Access Compliance Report

Public Rights-of-Way

(Pedestrian Signals)

Intersection ID: N/A	Main Street:	Cross Street: N/A	Location: N/A
ADA ID: C707A93C9C91	Signal Type: One Push Button-APS	Overall Compliance: No	Severity Score: BTN 1: N/A BTN 2: N/A No BTN: N/A
Codes/Mitigation Info/Possible Solution		Field Measurements/Component Compliance

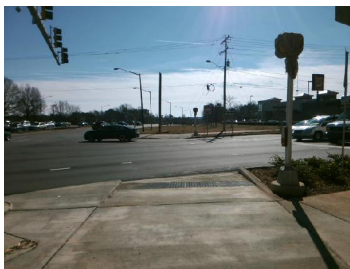
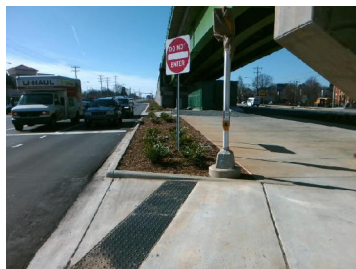
Surveyor Notes: NOT HOOKED UP, NOISES AND VERBAL COMMANDS UNKNOWN

PROW/ADA: TMUTCD 4e.08, R404.2, R404.7.2, R209.1, MUTCD 4e.10, R104.2, MUTCD 4e.08,

Possible Solutions: Replace Signal Push Button With APS Button on New Post. Remove & Relocate Sign.
